Paradise Business Centre

Lot 1, Block 1,
Paradise Valley Second Addition

Buildings 1, 2, 3, & 4

Revision Schedule		
△	Addendum	01/03/2025
△	Addendum	01/14/2025

OVERALL
SITE
PLAN

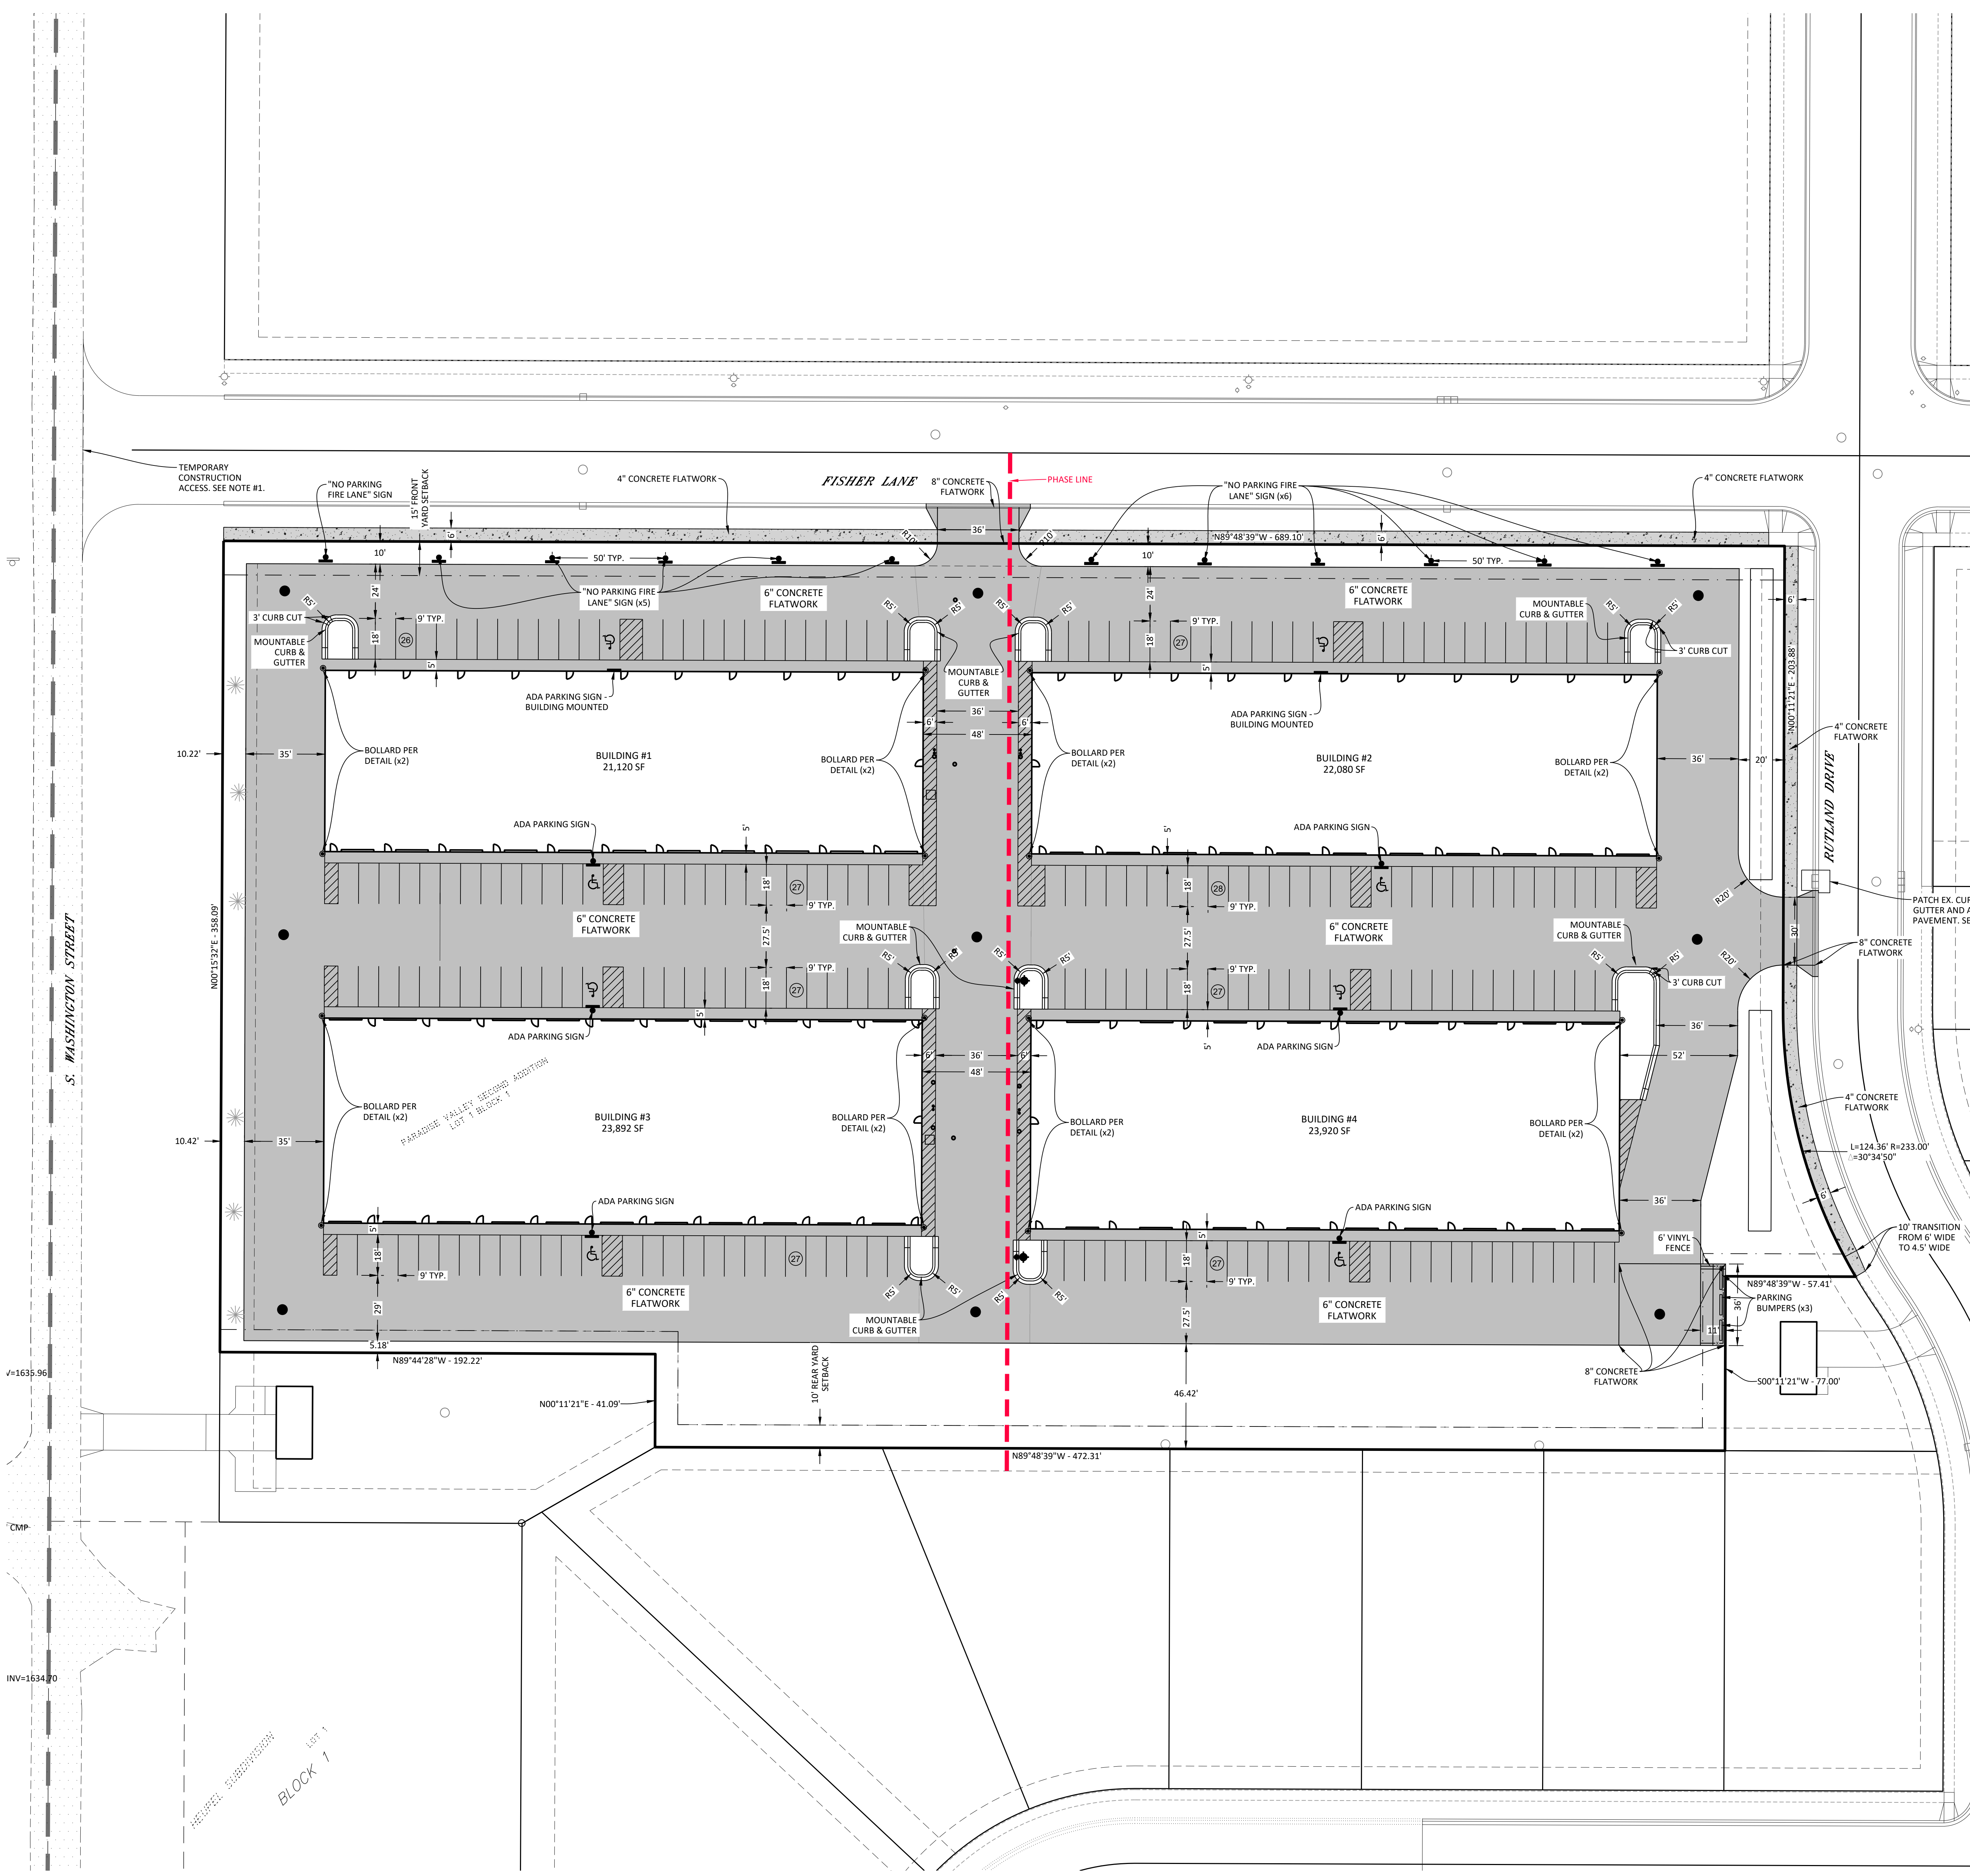
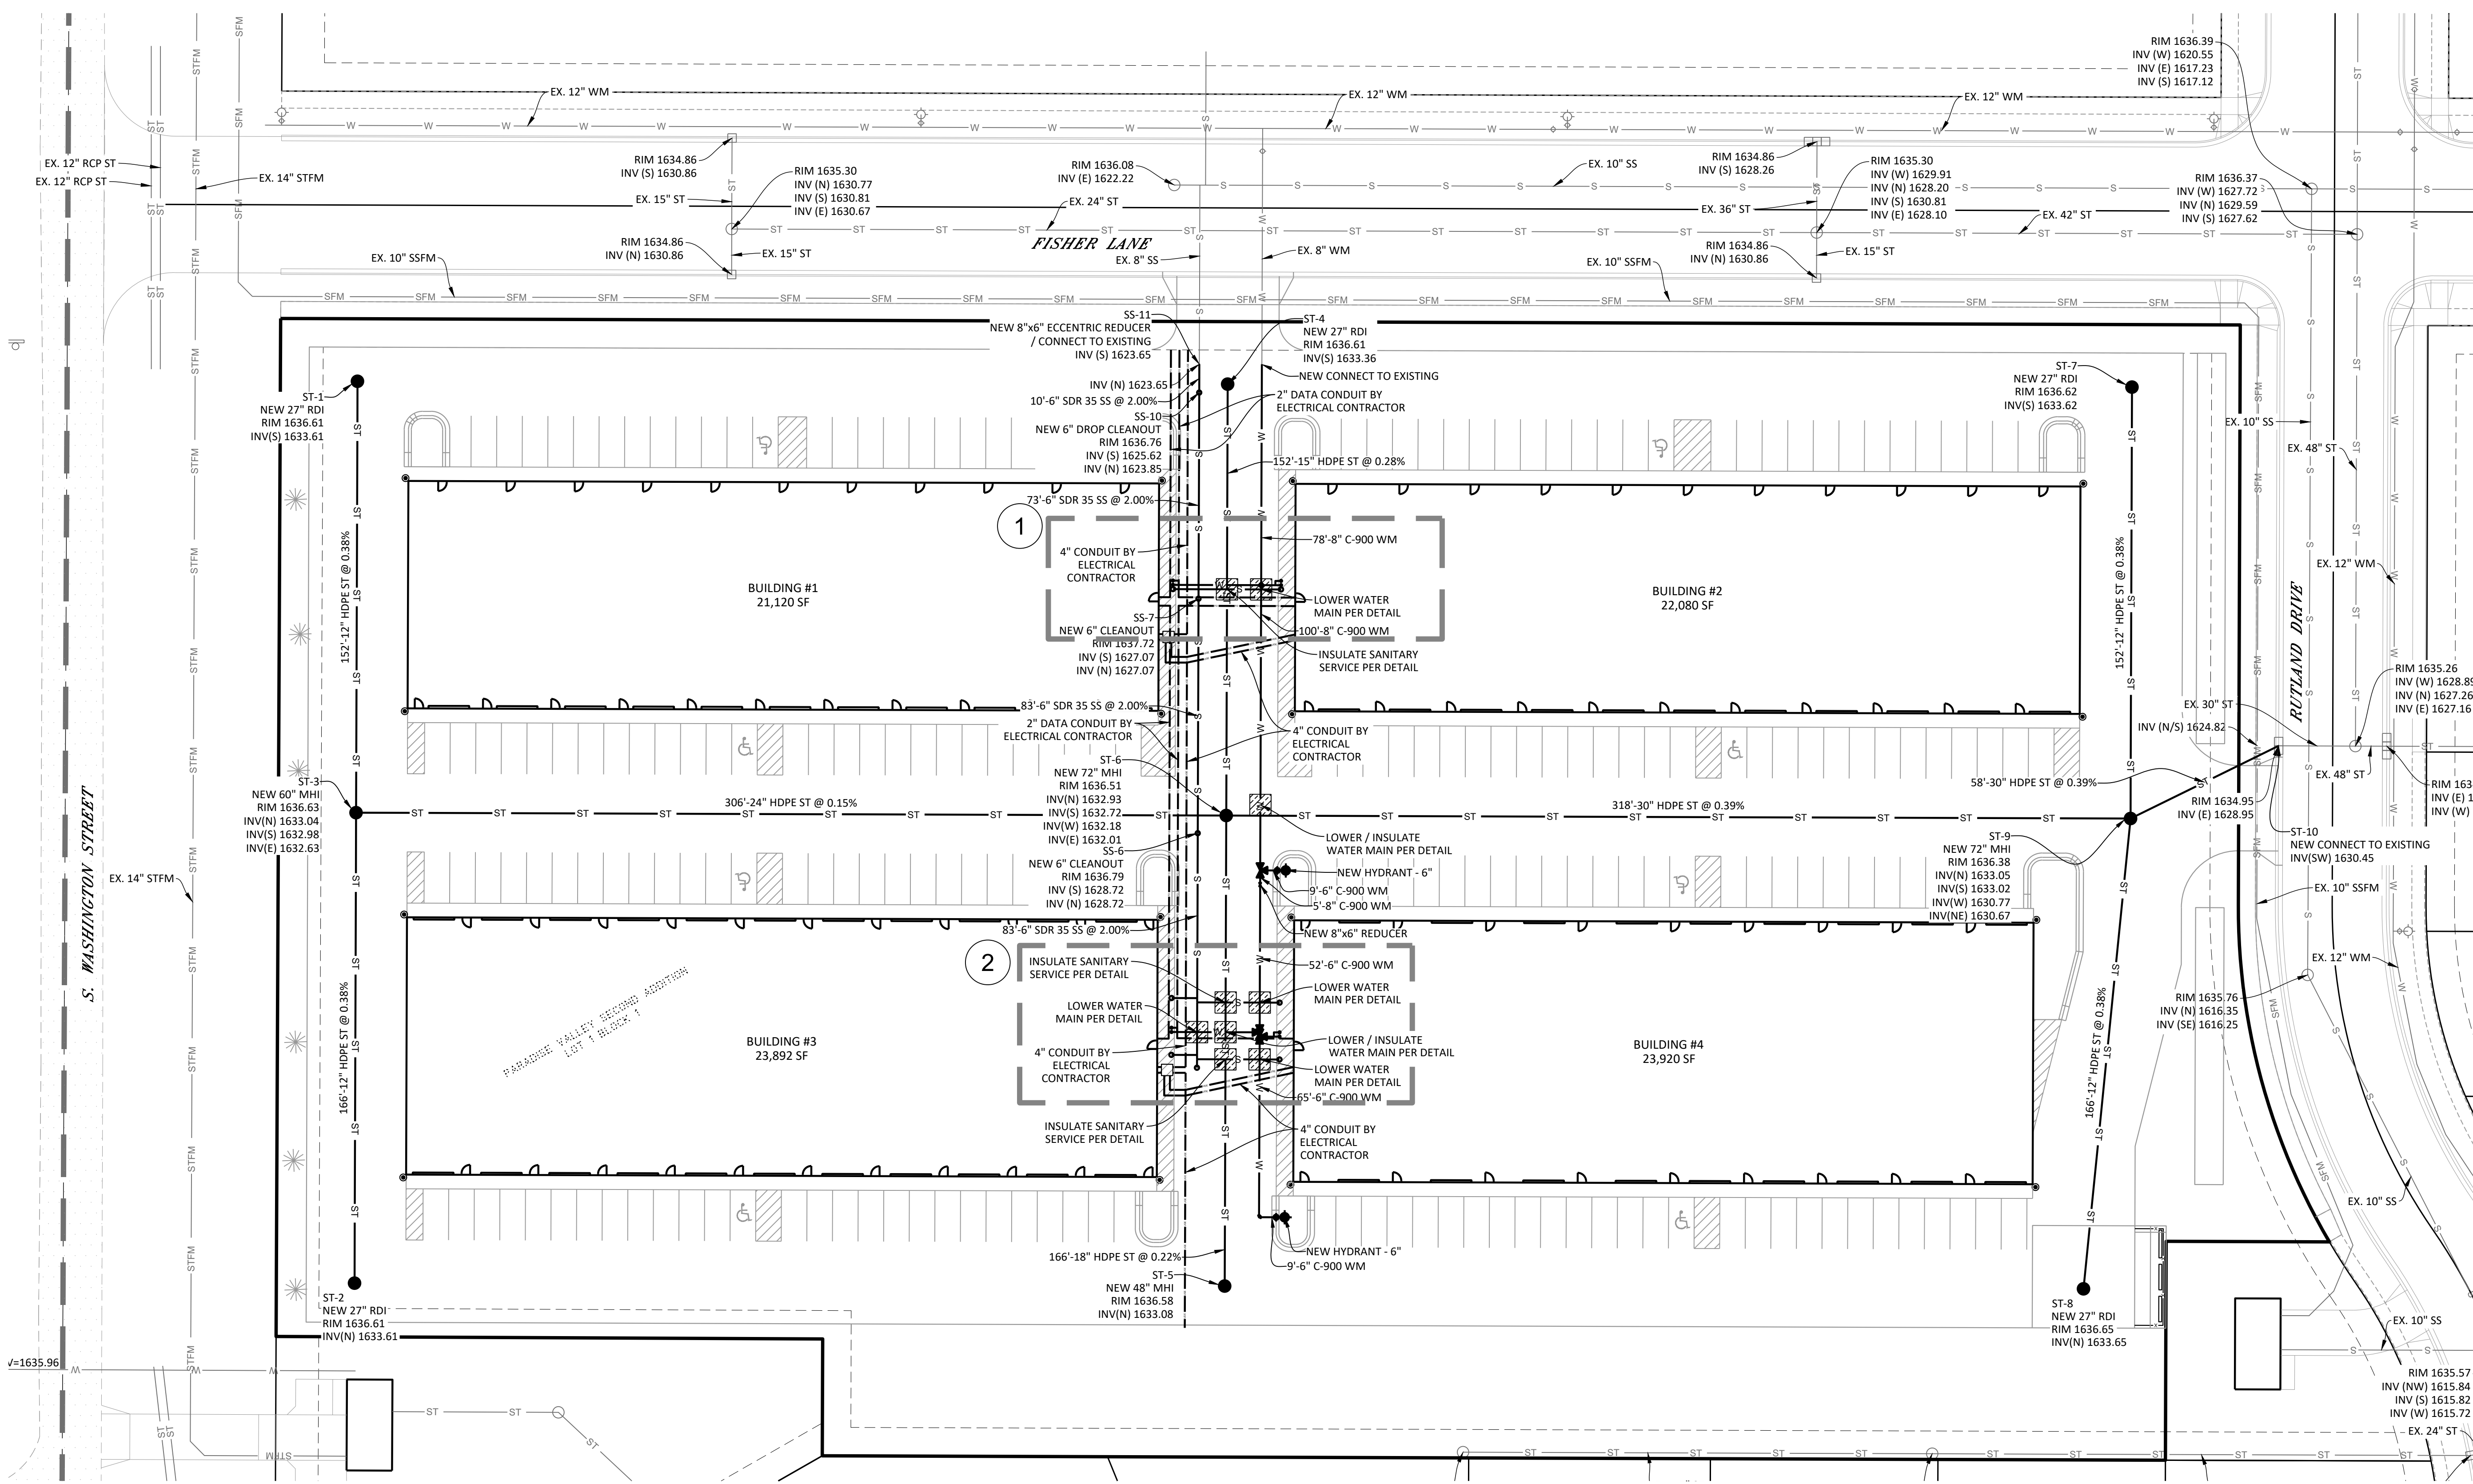
- REVISIONS PER CITY COMMENTS
- ADD PHASE LINE
 - ADD 5' WALKING SPACE ON SOUTH SIDE OF BUILDINGS #1 AND #2.
 - REDUCE WIDTH OF MIDDLE AND SOUTH DRIVE LANE TO 27.5'.
 - MODIFY WIDTH OF SIDEWALK IN RUTLAND DRIVE ROW TO BE 6' WIDE.
 - REDUCE WIDTH OF NORTH FLARE ON EAST DRIVEWAY.
 - REVISE LOCATION OF TEMPORARY CONSTRUCTION ACCESS AND NOTE #1.
 - ADD "NO PARKING FIRE LANE" SIGNS TO NORTH OF NORTH DRIVE LANE.
 - UPDATE QUANTITIES.
